Final
**Remedial Investigation/Feasibility Study
Work Plan**

for
AOC I and AOC R

at the
**Former U.S. Naval Ammunition Support Detachment (NASD)
Vieques Island, Puerto Rico**

August 2004

Figure 1-2
AOC I and AOC R Site Location Map
Former NASD, Vieques, Puerto Rico

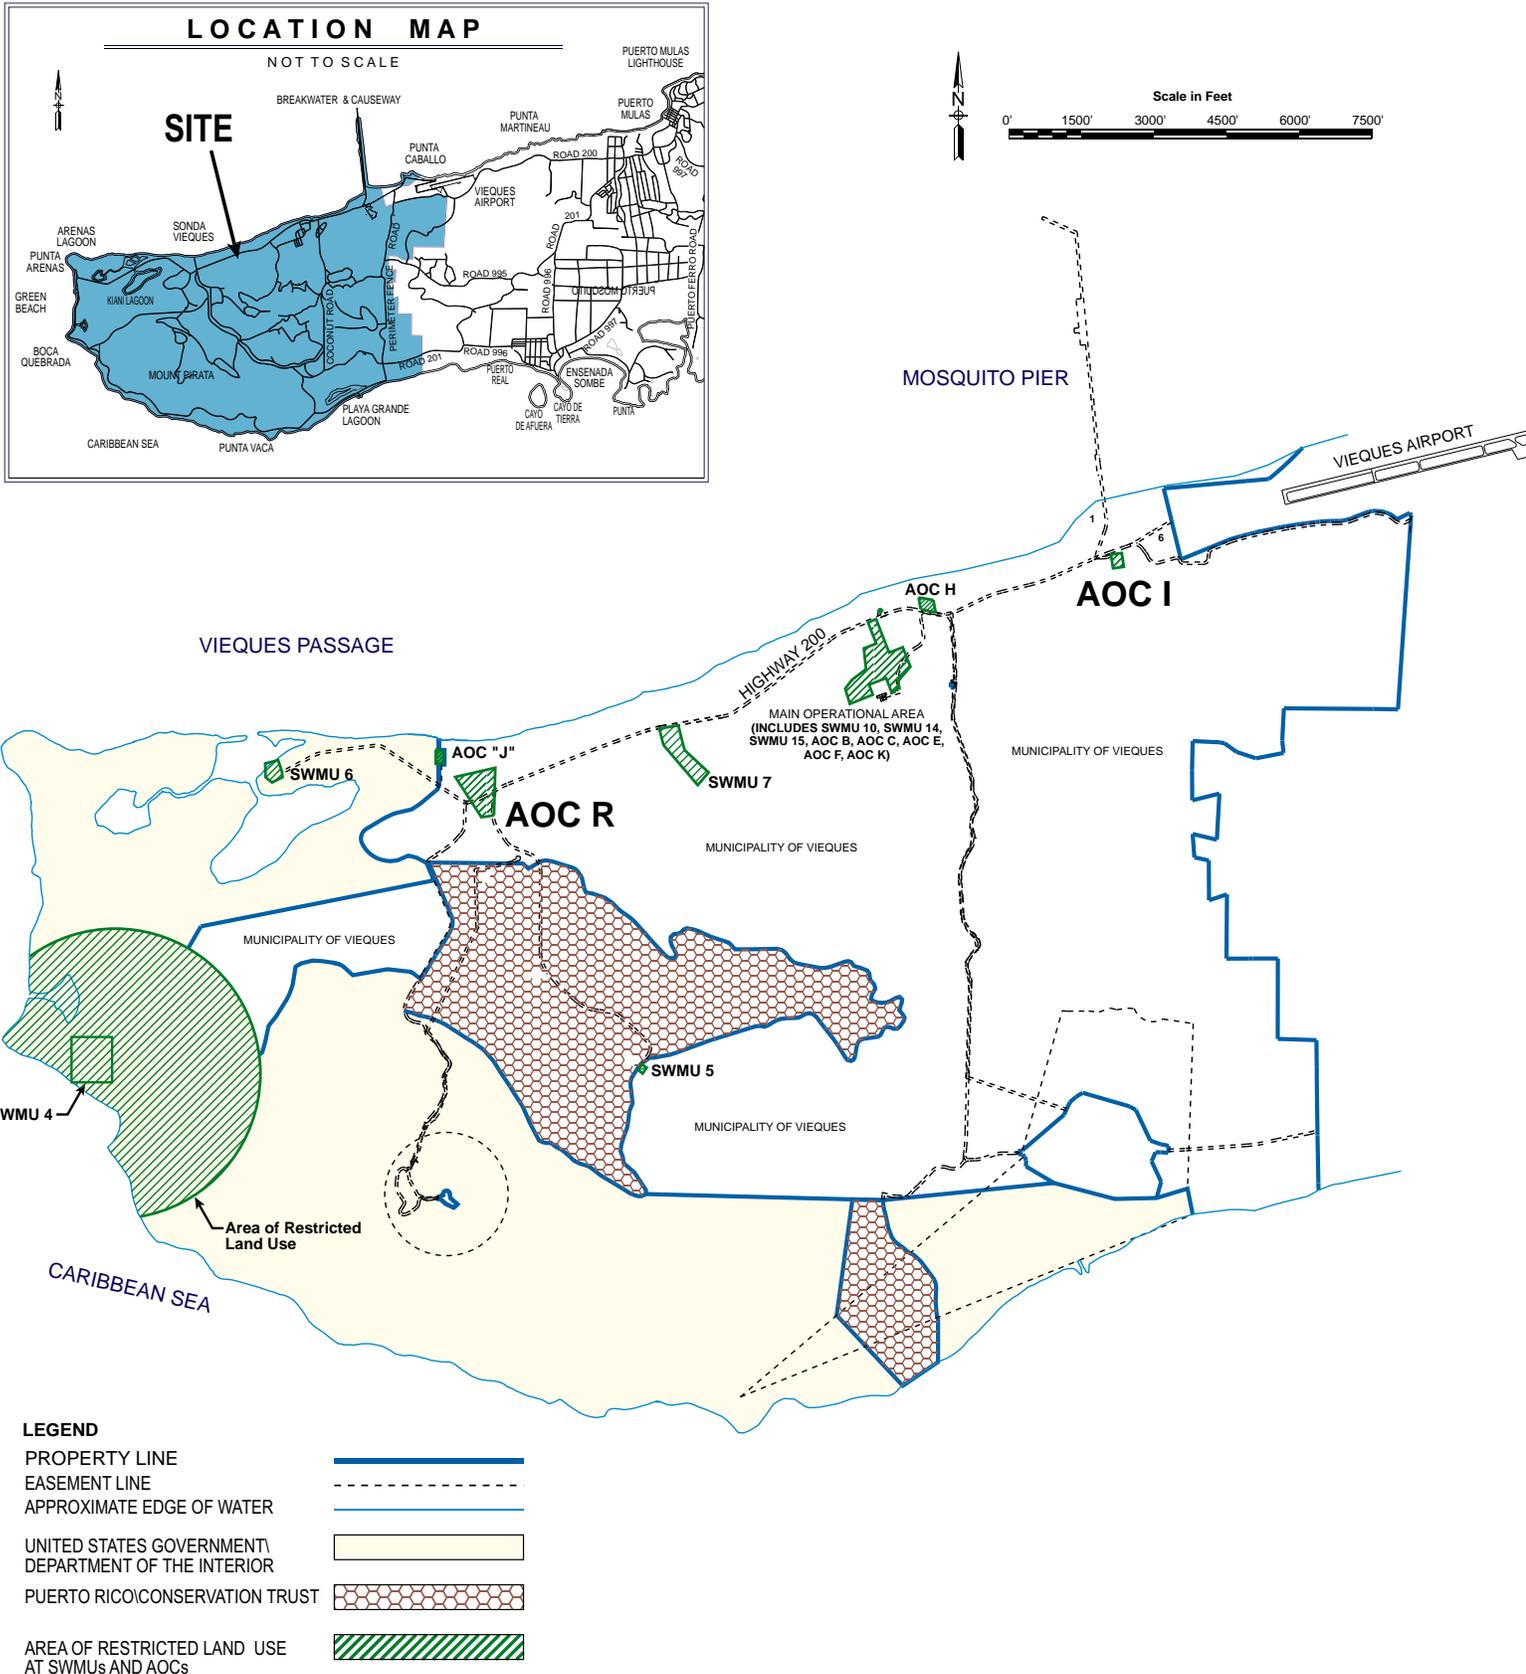
Figure 1-2: This figure depicts the locations of AOC I and AOC R on the northwestern portion of Vieques Island. The site descriptions provided in the Executive Summary on pages ES-1 and ES-2 note that AOC I is located 1,500 feet south of Mosquito Pier. However, the work plan does not indicate how far from the coastline AOC R is located. This information is needed to determine the adequacy of the down gradient soil sampling proposed. Further, the size of AOC R should be provided.

The distance of AOC R from the coastline is approximately 580 ft, which can be determined from Figure 1-2. The scale on the figure is shown in the upper right hand corner. A sentence has been added in the Executive Summary on page ES-2 under the Section marked AOC R-Former Construction Staging Area and AST; the second sentence now reads: “The site is located along Highway 200 approximately 1.5 miles east of Laguna Kiana and 580 feet south of the coastline.”

Figure 1-3
Aerial Photography, AOC I
Former NASD, Vieques, Puerto Rico

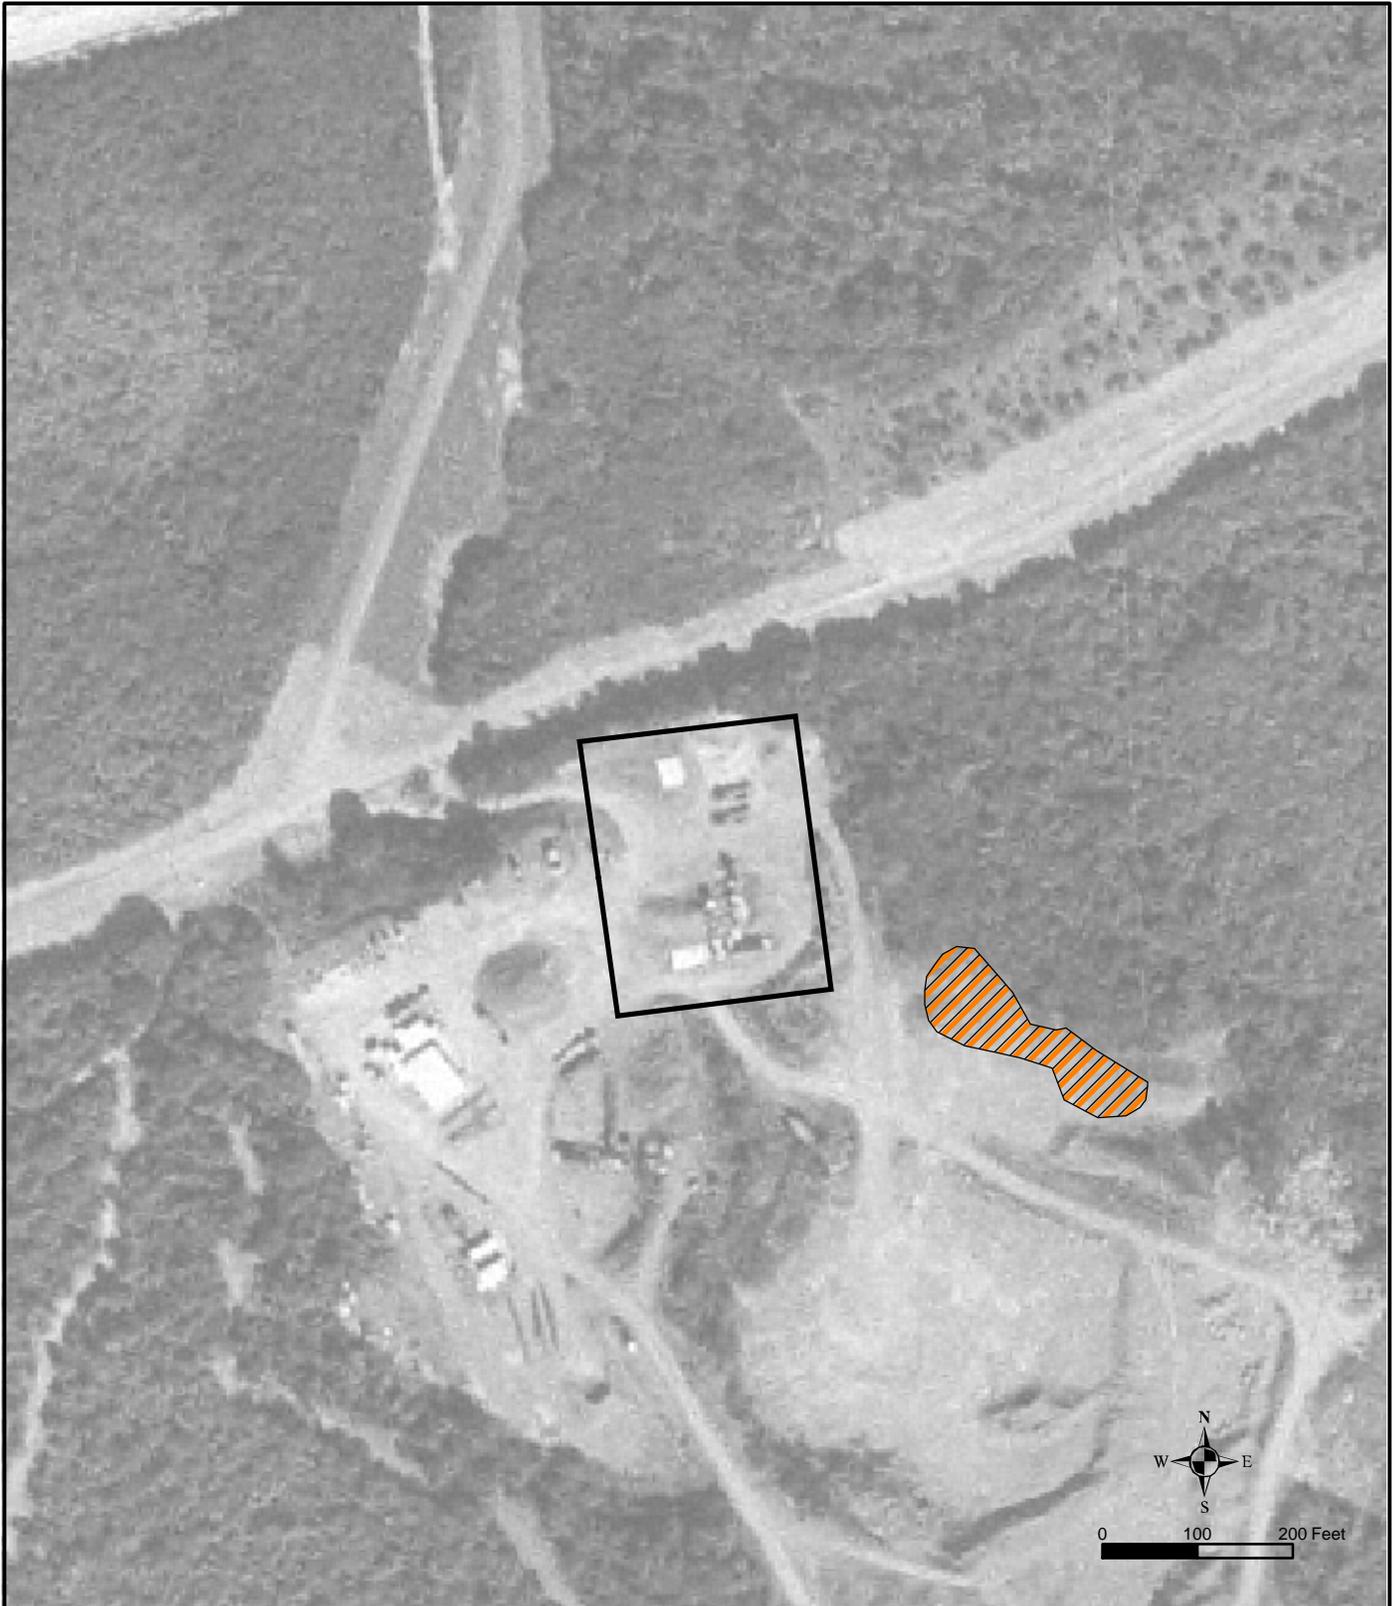
Figure 1-3 – Is the black line outline the “AOC boundary” or the “access restriction boundary”? Figure 1-3 uses “access restriction” terminology.

Figure 1-3 has been edited. Access Restriction Boundary was added.

Figure 2-7
AOC I Surface Soil Detections Above Screening Criteria and Background
Former NASD, Vieques, Puerto Rico

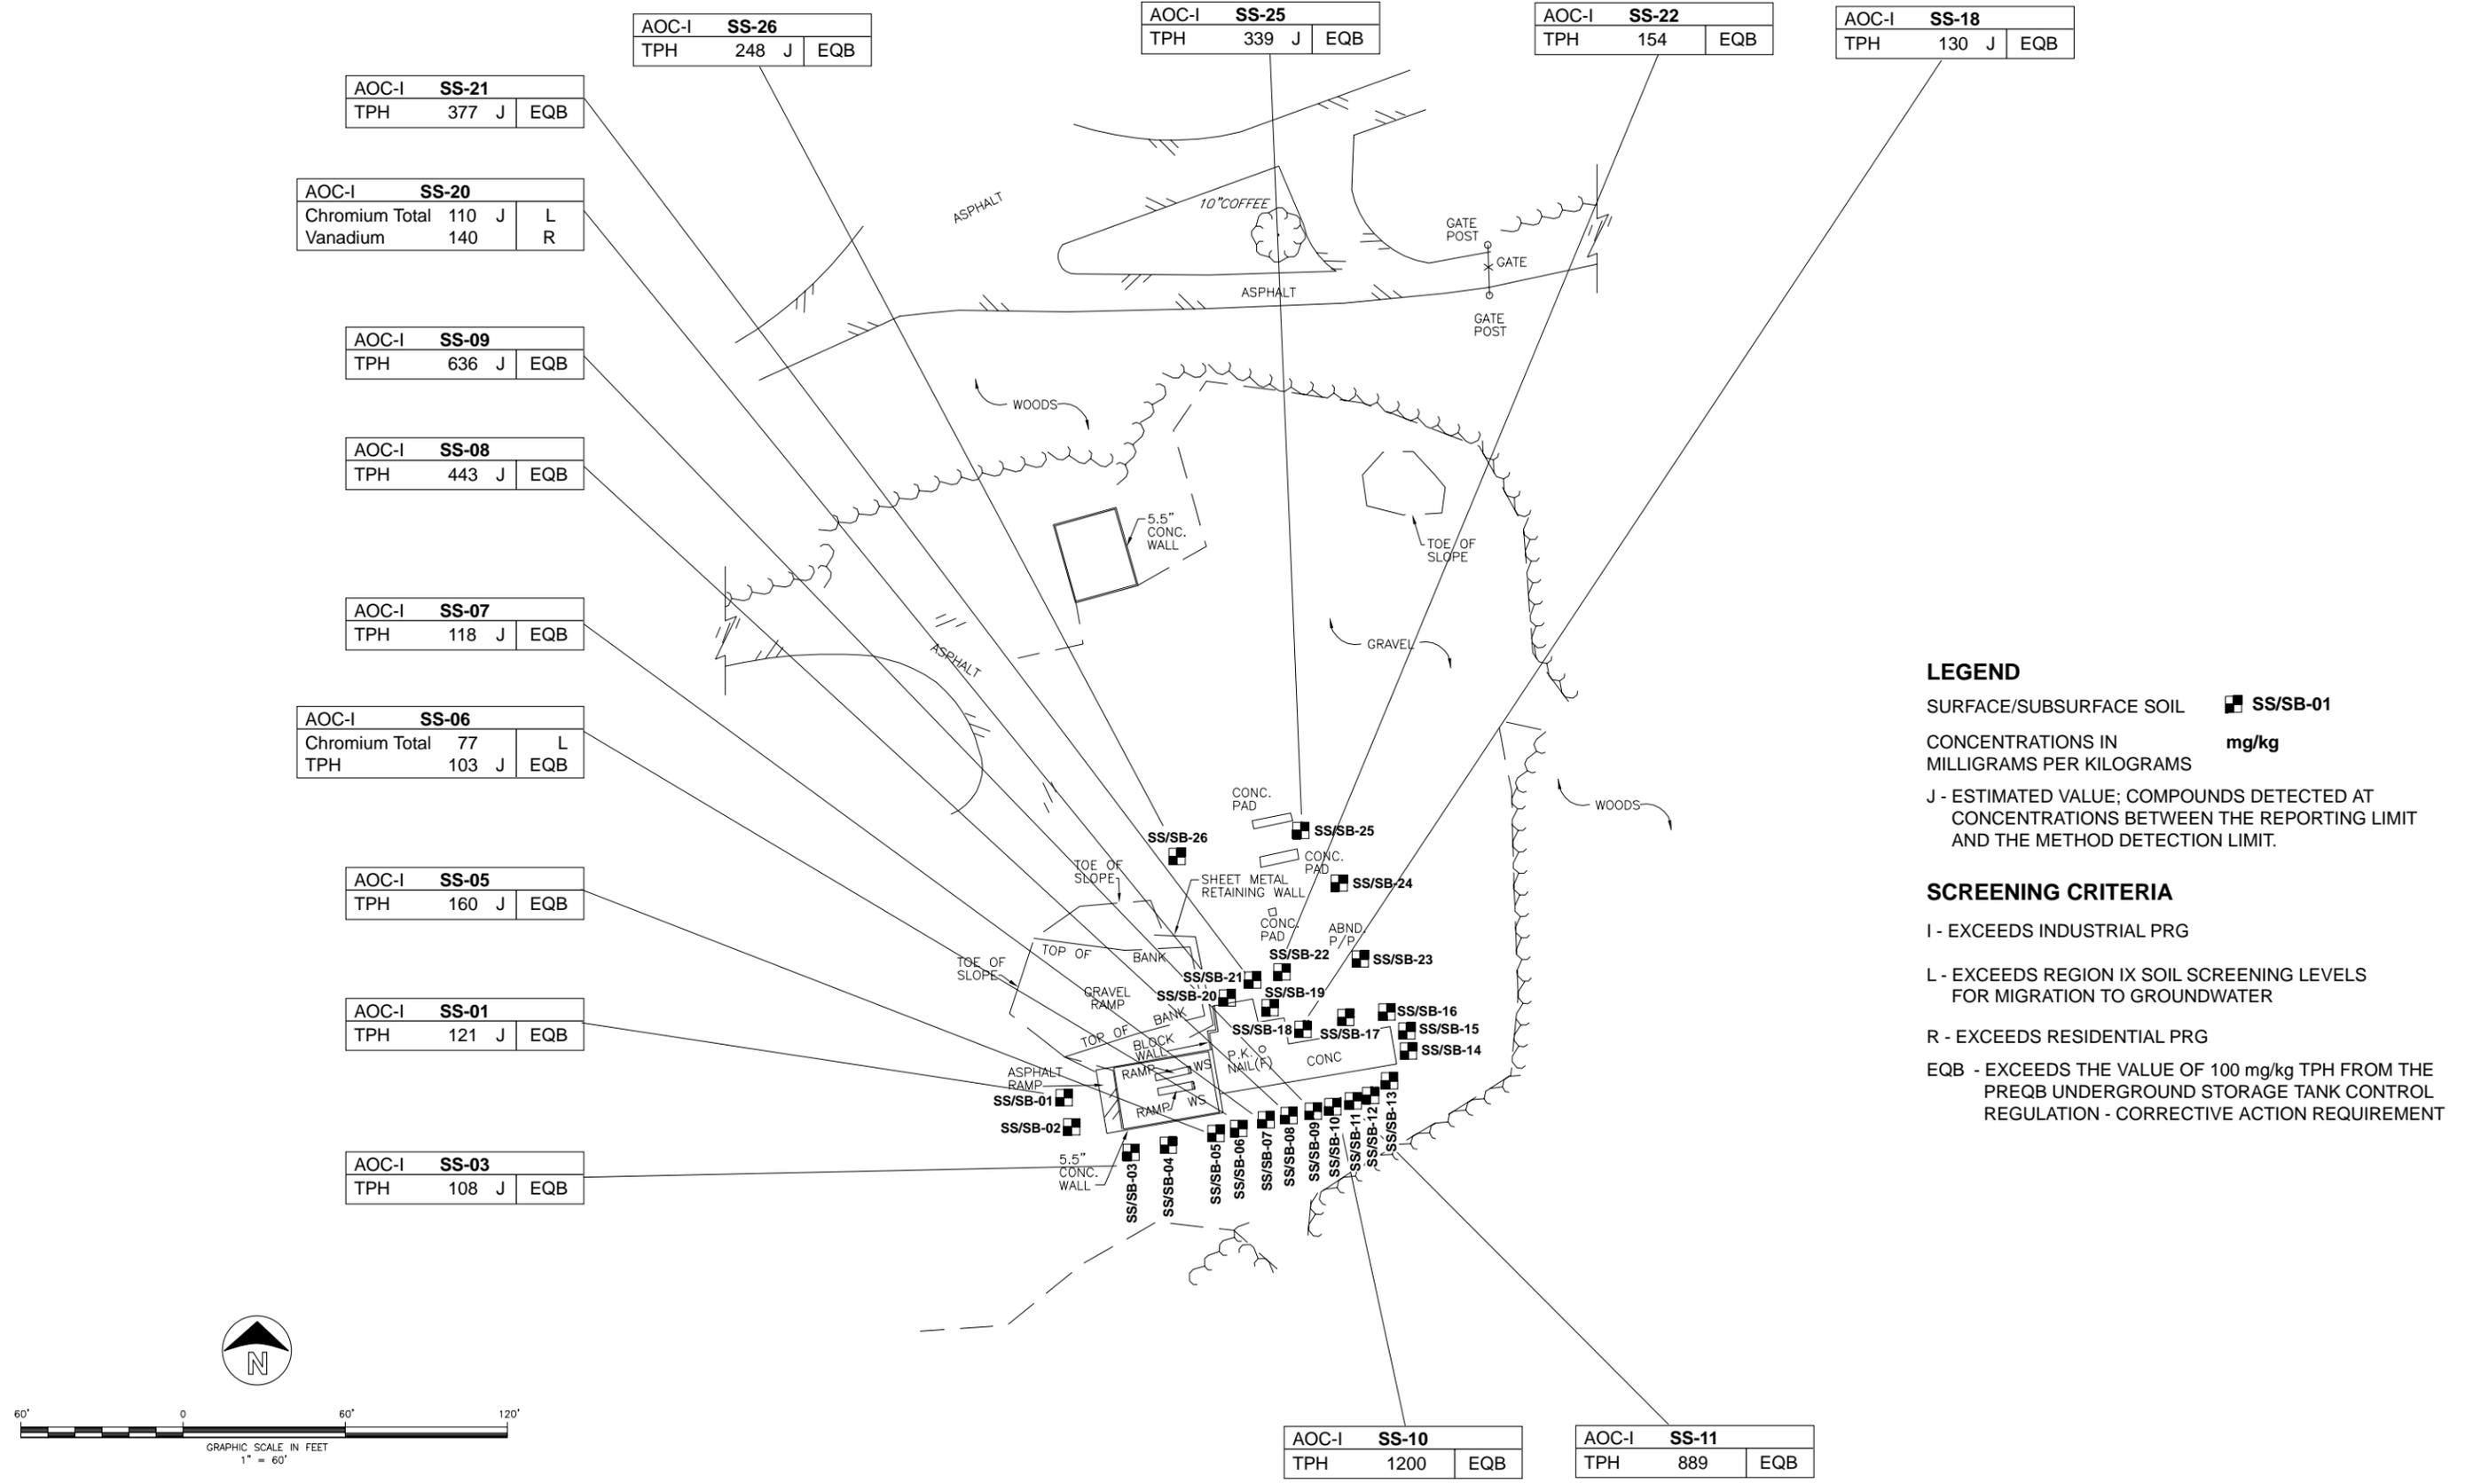
Figure 2-1: There are a few errors in this figure, and in others throughout the document:

- 1) **Mg/Kg has been changed to mg/kg for consistency (Figure 2-7)**
- 2) **Concentrations was changed to concentrations**
- 3) **The 100 mg/kg is an EQB recommended value, which has been added to the figure legend. Legend has been modified to eliminate the other impertinent qualifiers.**
- 4) **Title of Figure says Surface Soil Detections for Figure 2-7 and Subsurface Soil Detections for Figure 2-8. Each location with an exceedance is listed as SS for surface soil or SB for soil boring. The identifier SS/SB is shown in the legend to show that the surface soil and soil boring samples were collected from the same location; therefore, no change is needed.**

Figure 2-8
AOC I Subsurface Soil Detections Above Screening Criteria and Background
Former NASD, Vieques, Puerto Rico

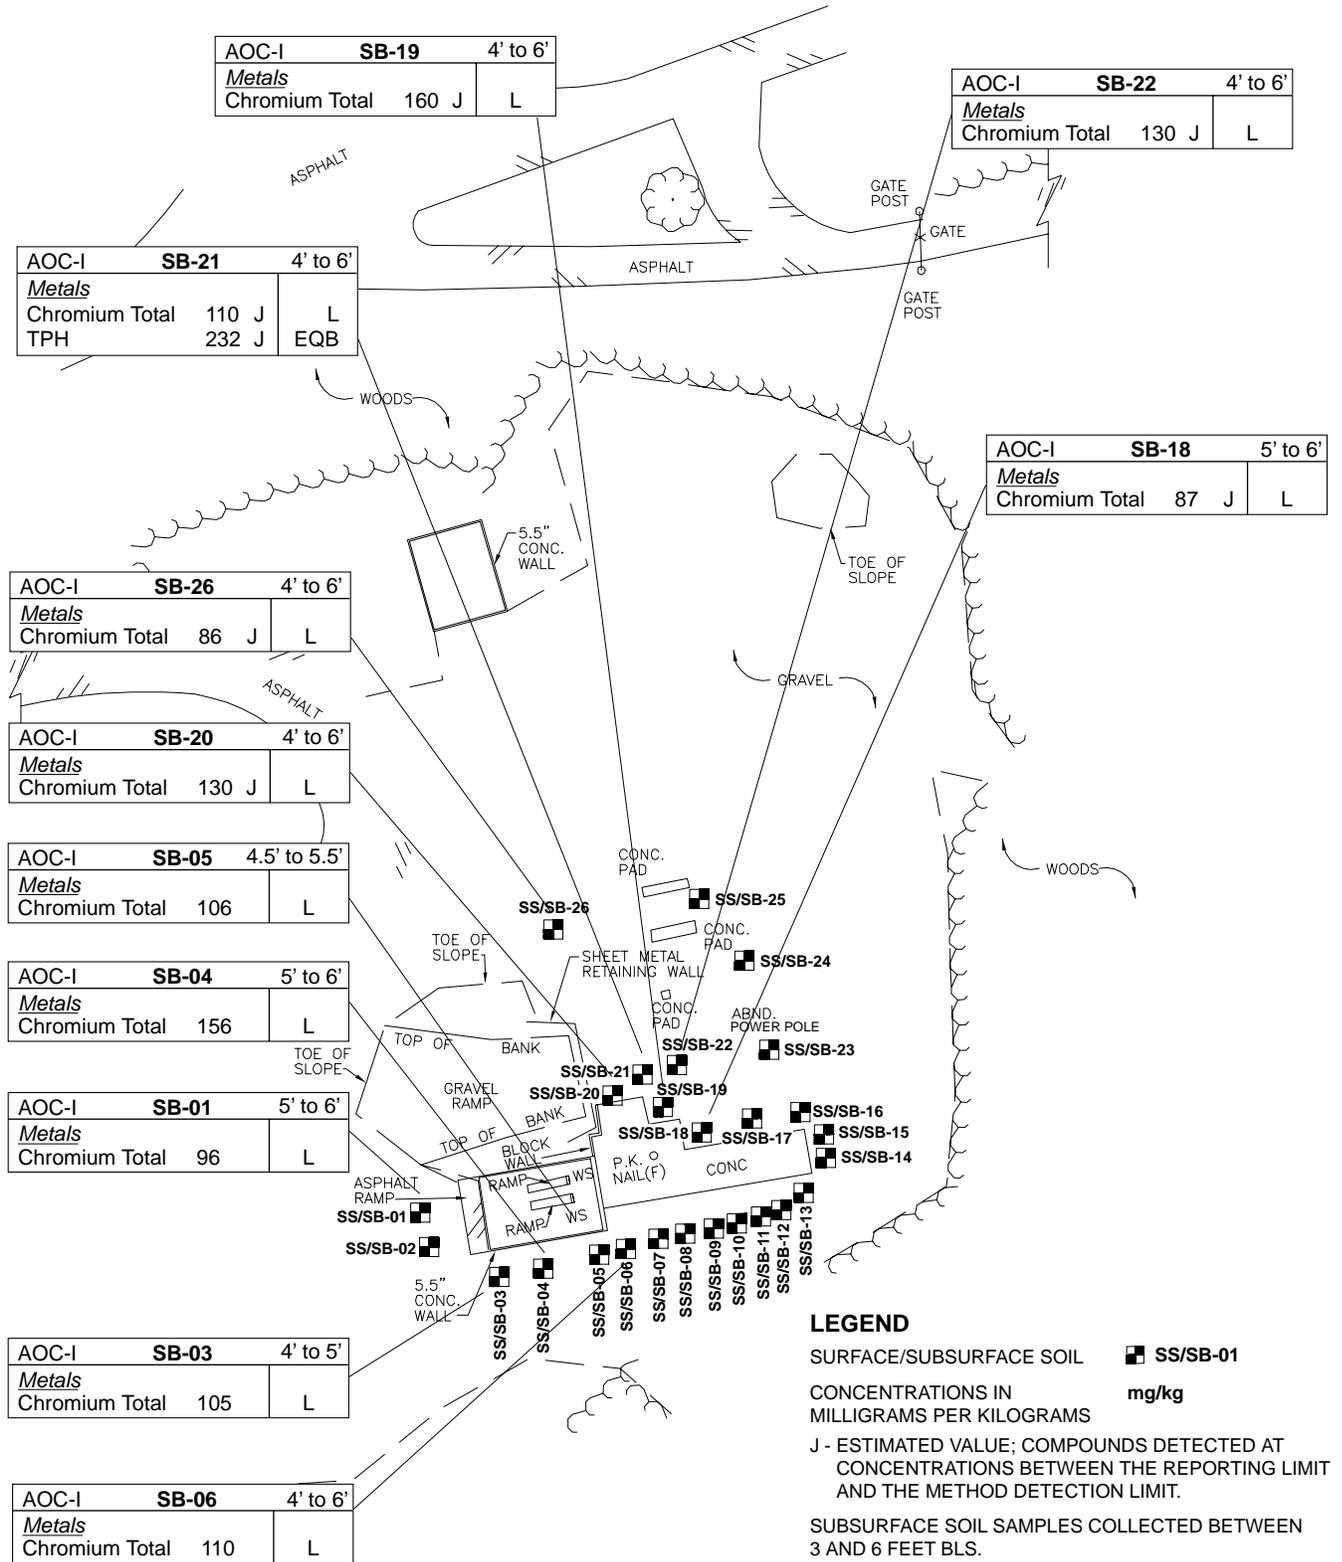
Figure 2-2 – Information must be provided regarding the depth of each soil boring, any field screening results, and the depth from which the sample submitted to the laboratory was collected.

Figure 2-2 (now Figure 2-8) has been edited to show the subsurface sampling depths. No field screening data are available for those samples.
